Addendum 01

DATE: March 7th, 2023

PROJECT: Tipp City Government Building Infill Addition
280 South Garber Drive
Tipp City, OH 45371

PROJECT #: 22094.0

SHEET NUMBER: A5.1

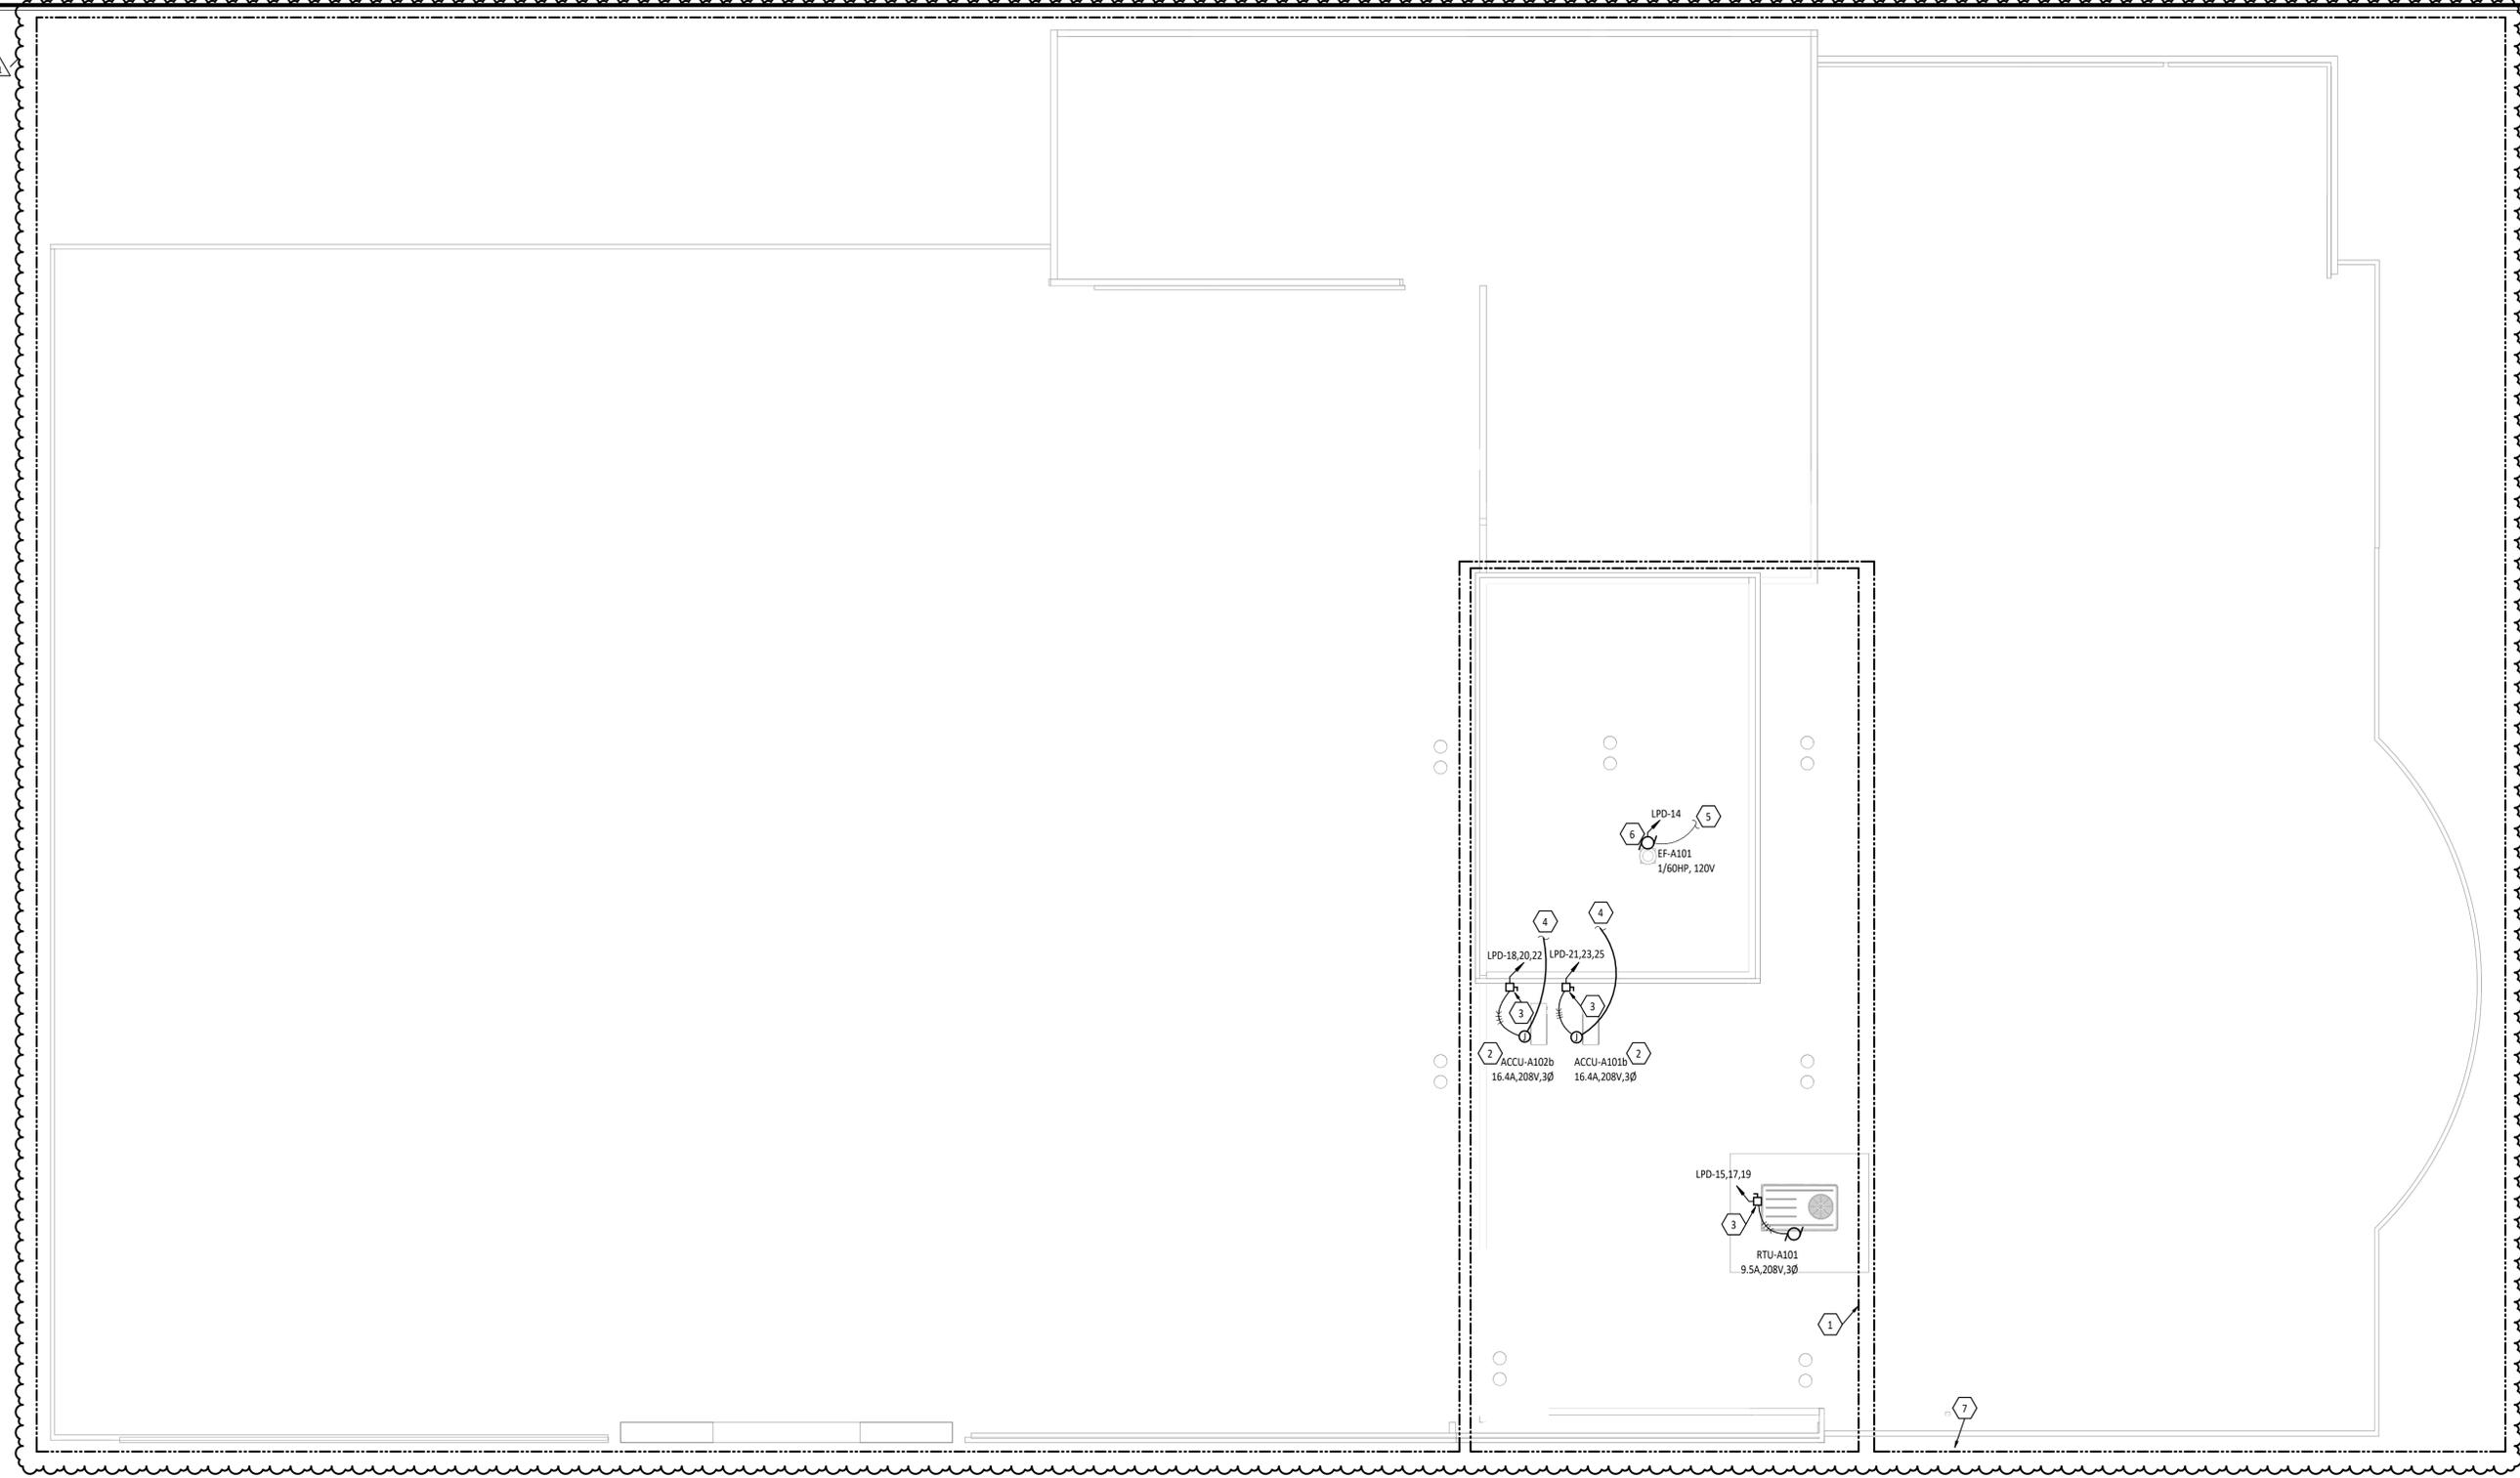
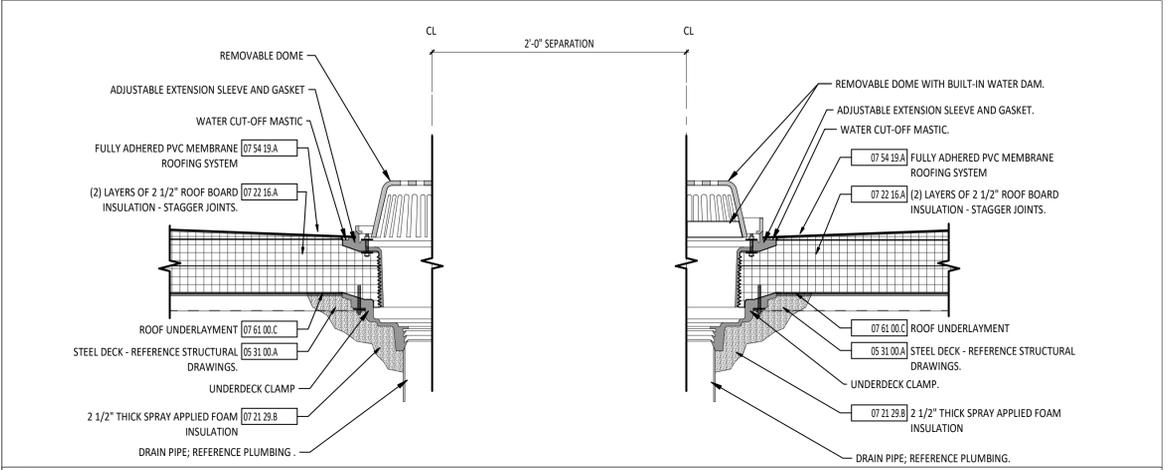
1. Drawing Sheet AD5.1 Roof Demolition Plan / Details: Detail 1 – Demolition Roof Plan: Revise detail as shown.
2. Drawing Sheet A5.1 Roof Plan: Roof Plan and Roof Details revise as shown.
3. Drawing Sheet FP1.1 FIRE PROTECTION PLAN: Detail 1 FIRE PROTECTION PLAN - MEZZANINE: Revised the drawings to show the mezzanine level of the fire suppression system.
4. Drawing Sheet M2.1 First Floor Mechanical Plan: Add keynotes 7 and 8 as shown.
5. Drawing Sheet E5.1 Roof Electrical Plan: Detail 1 Roof Electrical Plan: Revised the drawing to show the modifications needed to the lightning protection system on the existing portion of the building.

**SHEET NUMBER:
 ES.1**

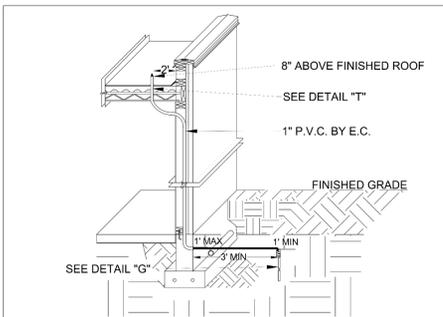
7	EXISTING LIGHTNING PROTECTION SYSTEM SHALL BE DISCONNECTED, TEMPORARILY SUPPORTED AND RECONNECTED TO ALLOW FOR ROOF REPLACEMENT IN THE EXISTING PORTION OF THE BUILDING. LIGHTNING PROTECTION SYSTEM SHALL BE MODIFIED AND RE-CERTIFIED BY MAXWELL LIGHTNING SYSTEMS. COORDINATE WORK WITH LIGHTNING PROTECTION INSTALLER AND ROOFING CONTRACTOR.

SHEET NUMBER:
M2.1

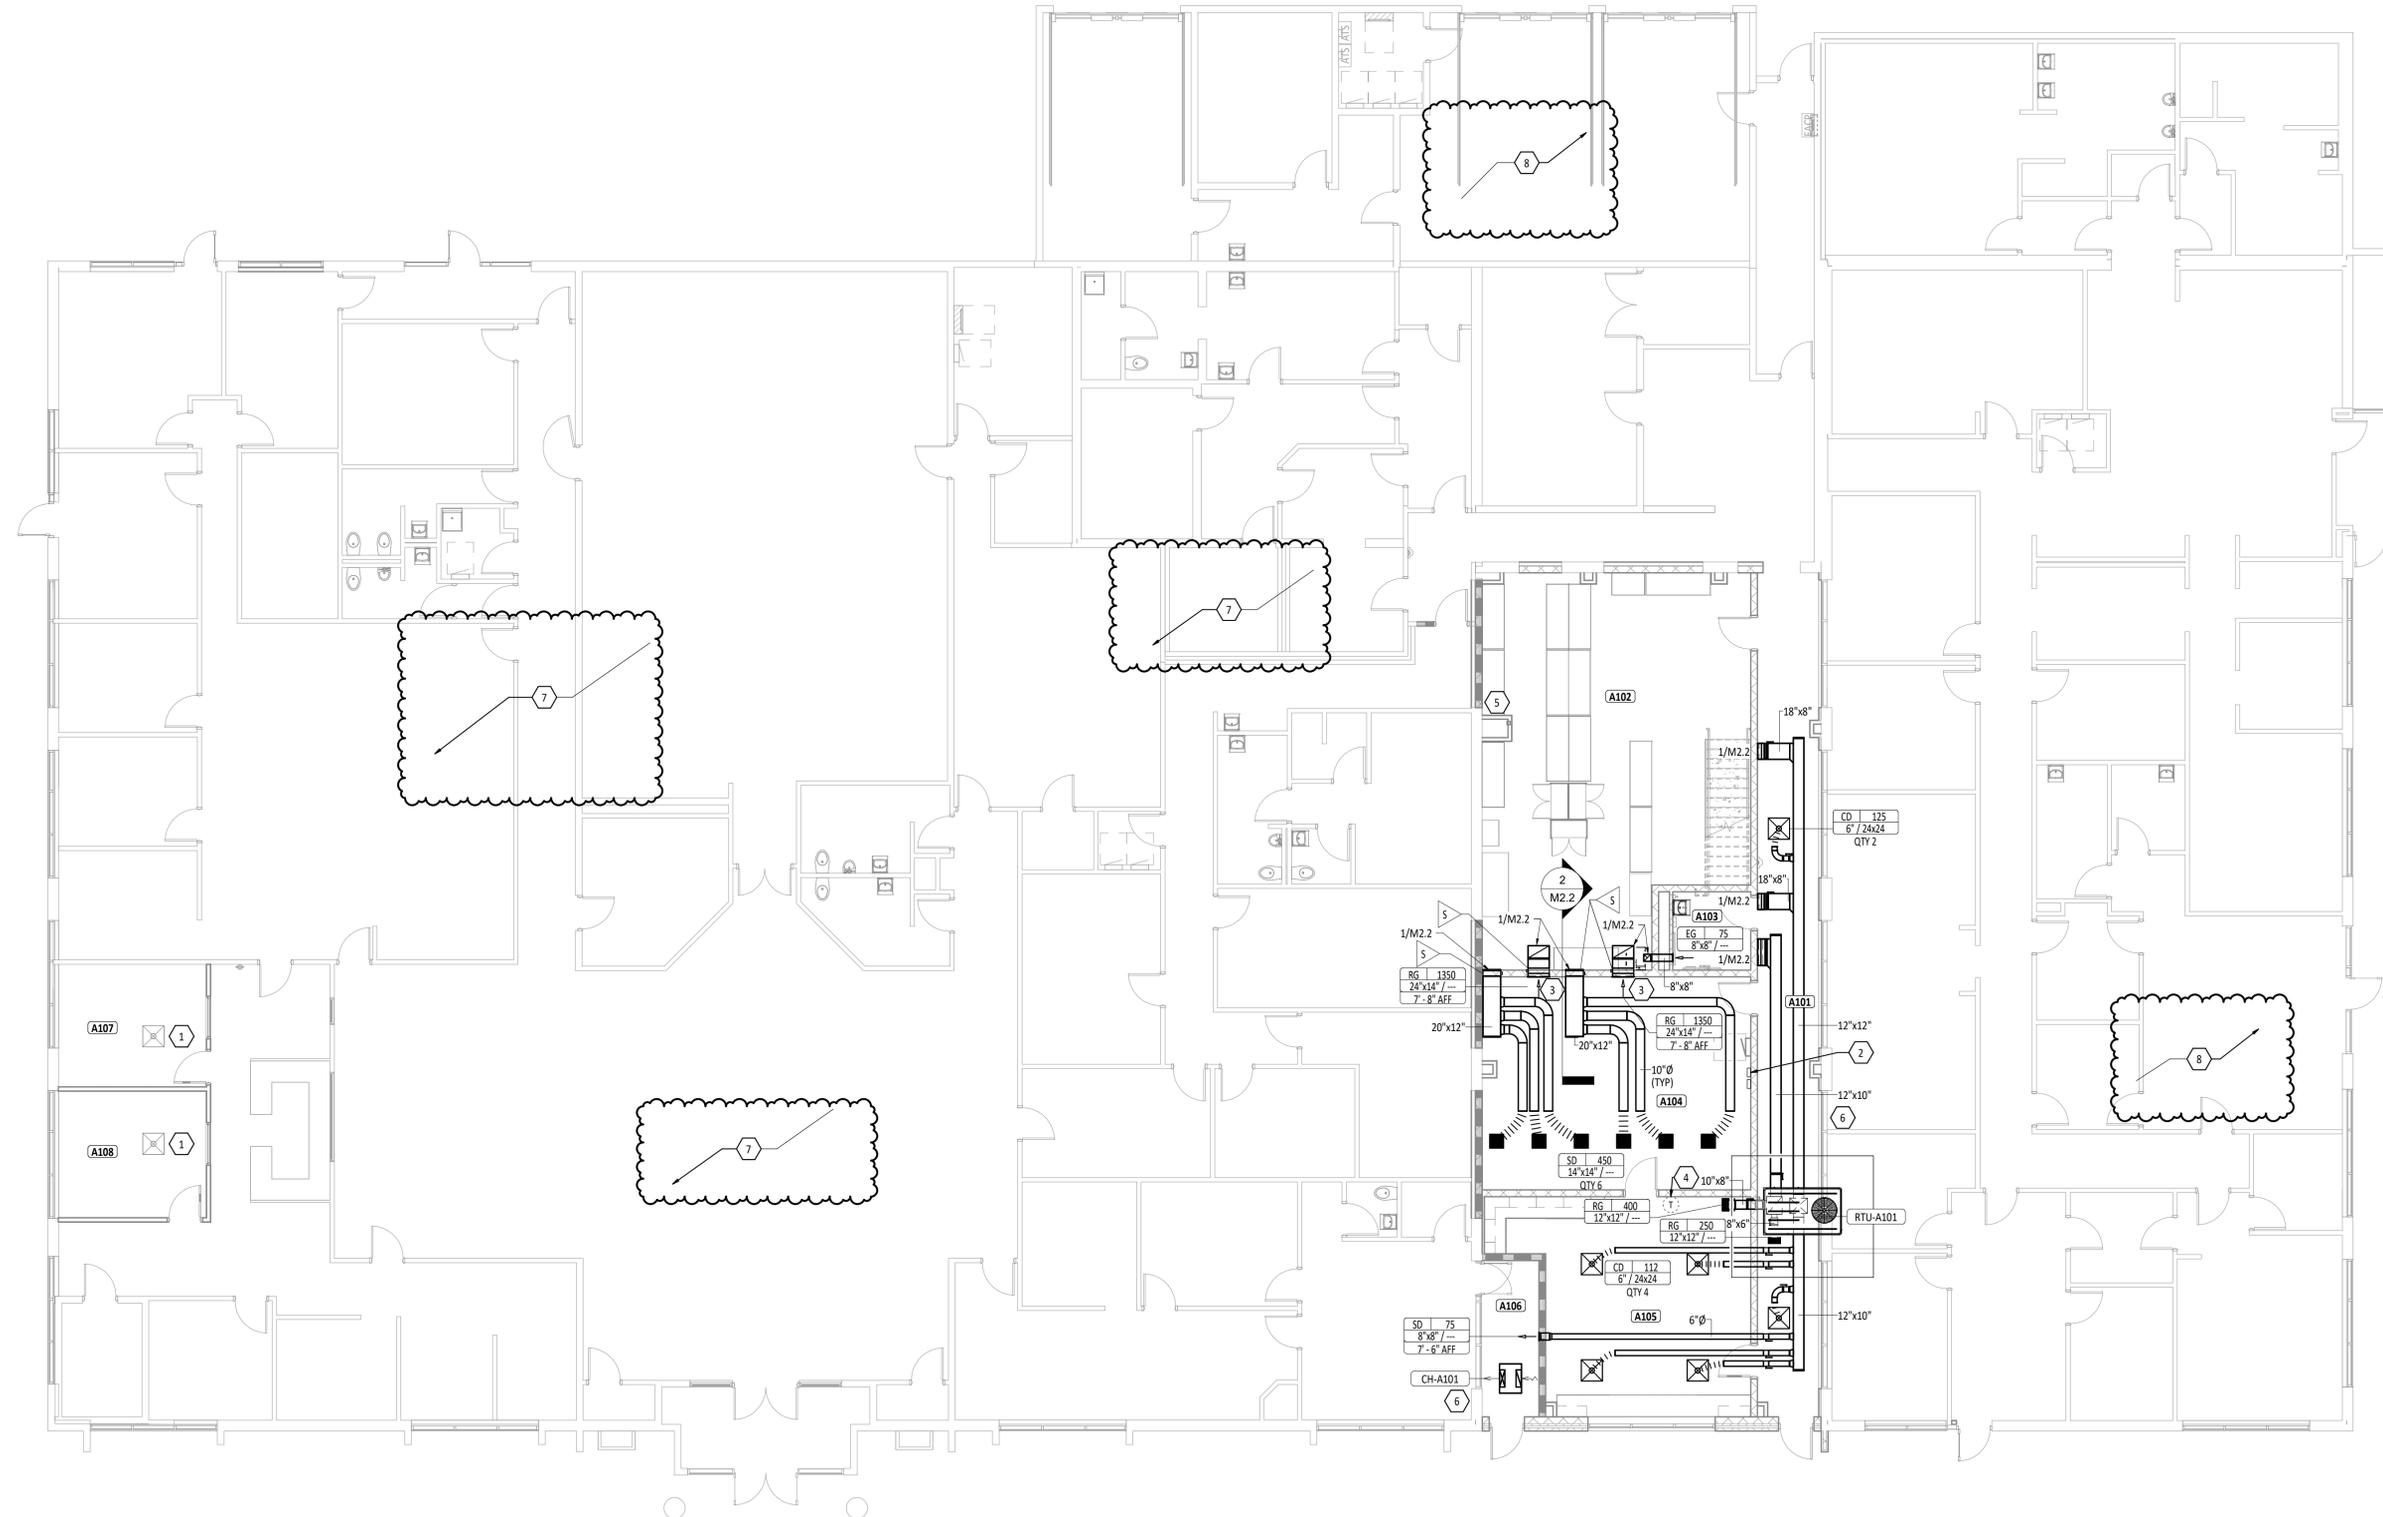
#	KEYNOTE DESCRIPTION
7	THERE IS A TOTAL FIFTEEN SPLIT SYSTEM CONDENSING UNITS MOUNTED ON ROOF ABOVE. THESE UNITS SIT ON PADS ON TOP OF THE ROOF. THE HVAC CONTRACTOR SHALL DISCONNECT REFRIGERANT PIPING AND POWER SO THAT EACH UNIT AND CORRESPONDING PAD CAN BE TEMPORARILY REMOVED FOR THE ROOF INSTALLATION AND THEN REINSTALLED AND RECONNECTED. CONTRACTOR SHALL INCLUDE PROPER EVACUATION AND RECHARGING OF REFRIGERANT AS REQUIRED.
8	THERE IS A TOTAL ONE SPLIT SYSTEM CONDENSING UNITS MOUNTED ON ROOF ABOVE. THESE UNITS SIT ON PADS ON TOP OF THE ROOF. THE HVAC CONTRACTOR SHALL DISCONNECT REFRIGERANT PIPING AND POWER SO THAT EACH UNIT AND CORRESPONDING PAD CAN BE TEMPORARILY REMOVED FOR THE ROOF INSTALLATION AND THEN REINSTALLED AND RECONNECTED. CONTRACTOR SHALL INCLUDE PROPER EVACUATION AND RECHARGING OF REFRIGERANT AS REQUIRED.
